Addendum No. 3
Solicitation 26-99071
Palm Street Smart Pond

ADDENDUM #3, February 3, 2026
Palm Street Smart Pond
City Project # 2208

PALM STREET PERMANENT STORMWATER MANAGEMENT
SYSTEM IMPROVEMENTS

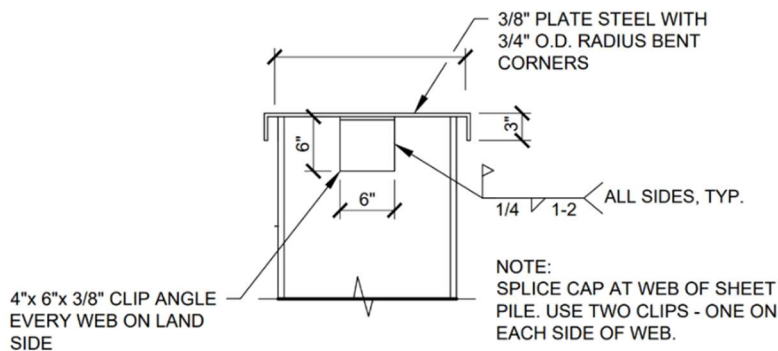
4. **Question:** Can you clarify the sheet pile and cap material properties for the project? Special Provisions call out the sheet pile to be A572 – Gr. 50. Plans call out on sheet RW01 (notes) (Weathering Steel). Please note Sheet Pile Cap is called out as Spec 3306 on sheet RW09.

Answer: Sheetpile shall be weathering steel, pile cap to meet Spec. 3306.

CONSTRUCTION CHARTS
SHEET NO. 7 OF 47 SHEETS

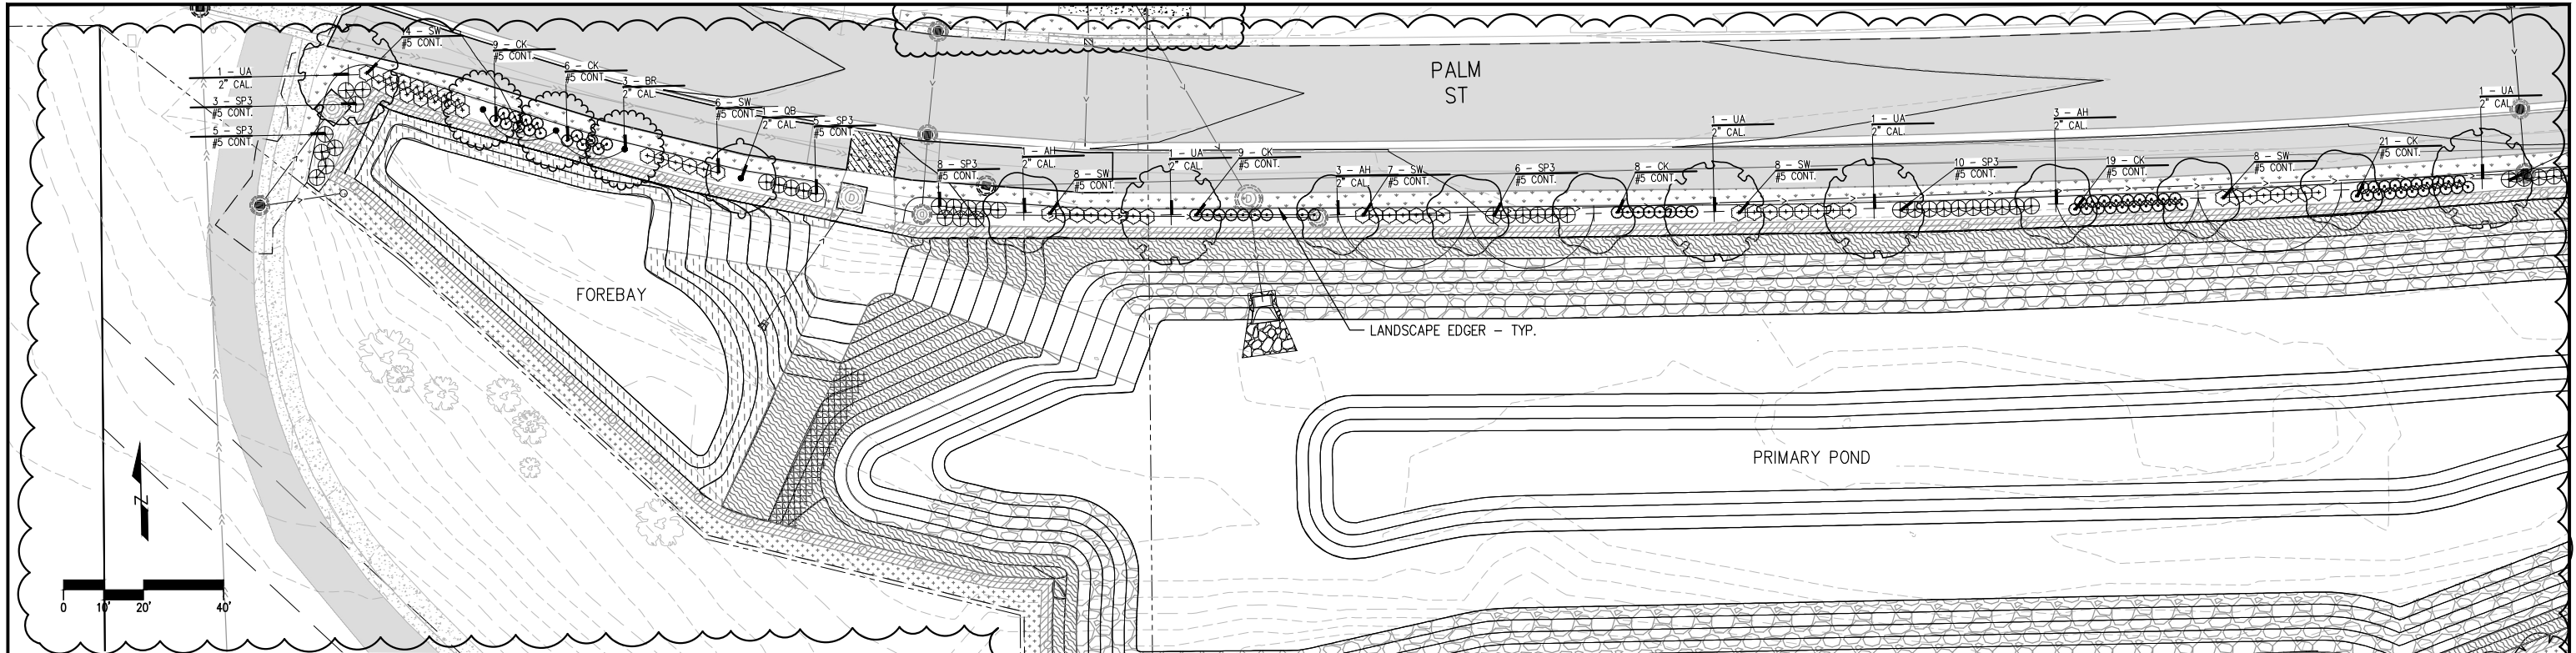
1. Drawing changes to the STATEMENT OF ESTIMATED QUANTITIES are as follows:
 - a. Sheet 4; Delete Sheet 4 in its entirety and replace with the attached revised Sheet 4.
2. Drawing changes to the CONSTRUCTION CHARTS are as follows:
 - a. Sheet 7; Delete Sheet 7 in its entirety and replace with the attached revised Sheet 7.
3. Drawing changes to the LANDSCAPE PLANS are as follows:
 - a. Sheet LA01; Delete Sheet LA01 in its entirety and replace with the attached revised Sheet LA01.

9. **Question:** It seems like the items contained within Restoration planting Zones 1, 2, and 3 are listed within items "perennial 4" cont", "Rolled erosion prevention cat 20", "Seeding", "Seed northeast roadside" and "Seed wet ditch". Are these redundant bid items or can you clarify what is to be bid on within the planting zones? Besides the willow wattles and live stakes.

Answer: Restoration Planting Zones 1, 2 and 3 include the following: Subsoiling, soil bed prep, planting soil and other soil amendments (beyond 4" topsoil borrow), seeding, perennial plugs, plug planting, willow stakes & bundles, fertilizer, watering, and hardwood mulch. The required 4" of topsoil borrow and rolled erosion prevention in planting zones are paid as separate bid items. Perennial 4" cont. bid item was removed and perennial plugs are included in the planting zones. There are areas outside the planting zones that will be seeded with NE Roadside and Wet Ditch seed. The seed, seeding and fertilizer for these areas are paid as separate bid items. See revised plan sheets.

LANDSCAPE PLANS
SHEET NO. LA02 OF LA03 SHEETS

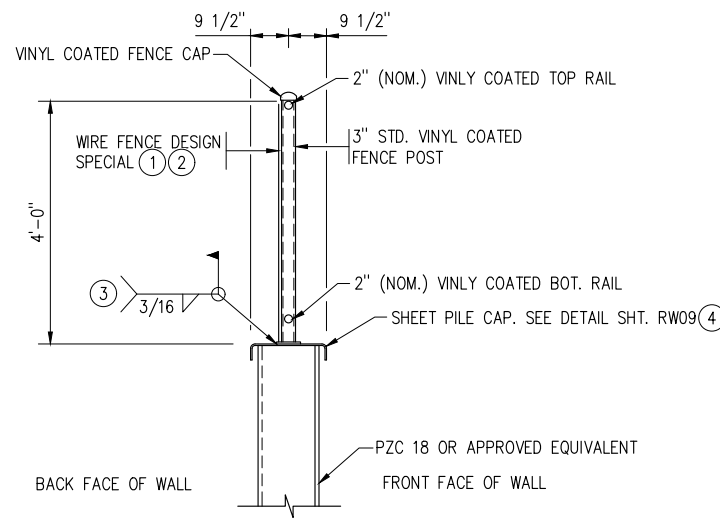
4. Drawing changes to the LANDSCAPE PLANS are as follows:
 - a. Sheet LA02; Delete Sheet LA02 in its entirety and replace with the attached revised Sheet LA02.

10. **Question:** Can you verify full inspection, maintenance and warranty requirements for landscaping? On LA02 it says to refer to specs for them, but the specs do not outline any maintenance, warranty requirements.

Answer: Follow MnDOT standard specification 2571 for plant maintenance and establishment period, replacement requirements, and acceptance of the work.

FENCE DETAILS – ALTERNATIVE DESIGN
SHEET NO. RW09A OF RW09 SHEETS

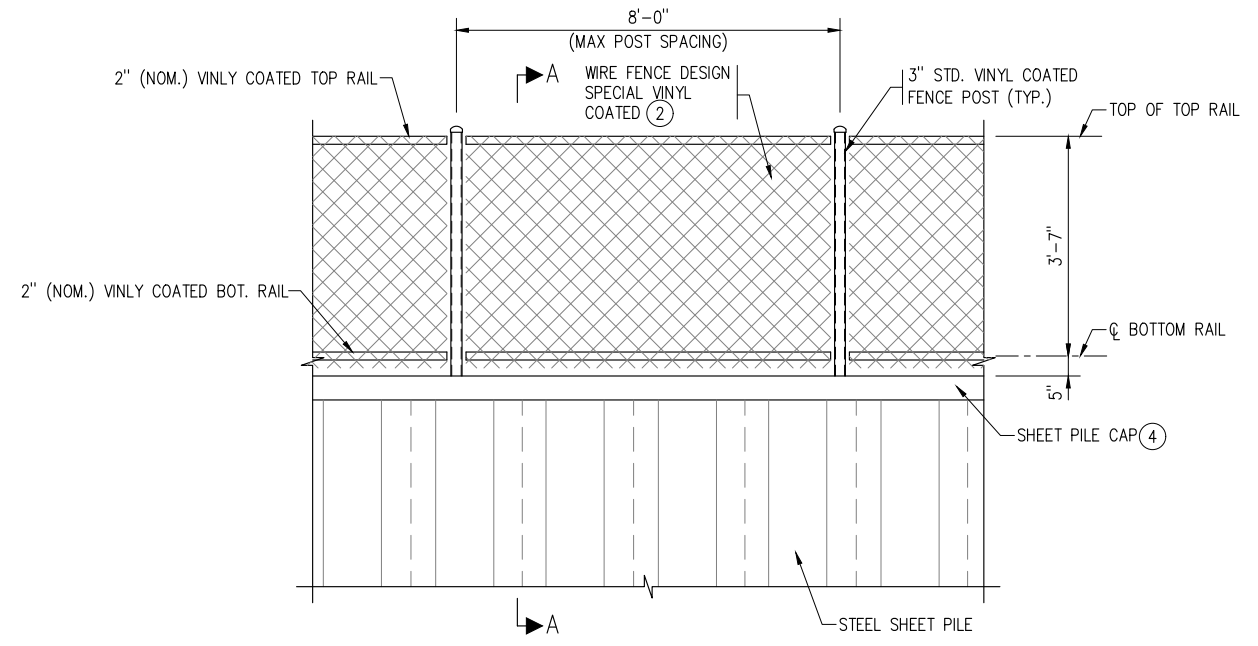
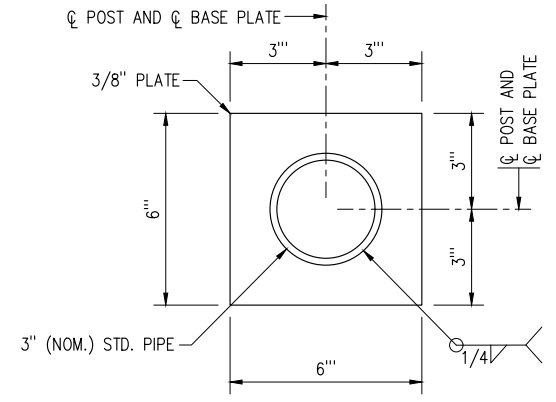
5. Drawing changes to the RETAINING WALL PLANS are as follows:
 - a. Add sheets RW09A, do not delete RW09

7. **Question:** Can alternative fence details be used?

Answer: See sheet RW09A for an alternate fence design from that on sheet RW09, either system will be accepted.
